Supplemental/Bid Bulletin
Addendum No. 1

TITLE : Supply, Delivery and Installation of DSWD ARTA LED Wall
ITB NO. : DSWD7-PB-2024-58
DATE : 11 November 2024

ANNEX A

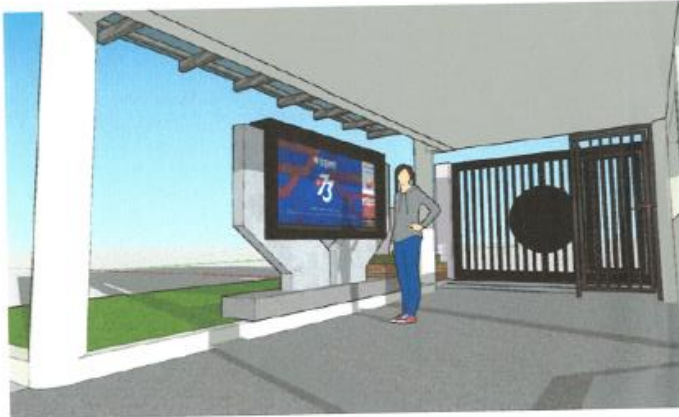
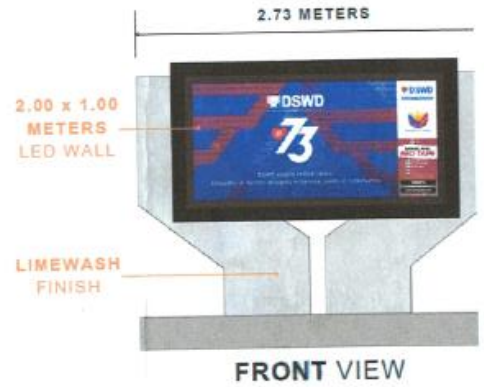
NO.	ITEM DESCRIPTION	STATEMENT OF COMPLIANCE	BIDDER’S REMARKS
1.	<p>OUTDOOR LED WALL (see Annex A)</p> <ul style="list-style-type: none"> <input type="checkbox"/> Support front and rear maintenance <input type="checkbox"/> Using aluminum chassis with good heat dissipation, workable under 60 °C <input type="checkbox"/> All series aluminum profile cabinets support IP67(F)/IP66(R) <input type="checkbox"/> Apply unique technology, maximally saving 30% energy <input type="checkbox"/> Various cabinet sizes, applying to diverse scenes <input type="checkbox"/> The cabinets support customized 45° corner cut to realize 90° right-angle splicing <input type="checkbox"/> Pixel pitch: maximum of 2.9 mm pitch
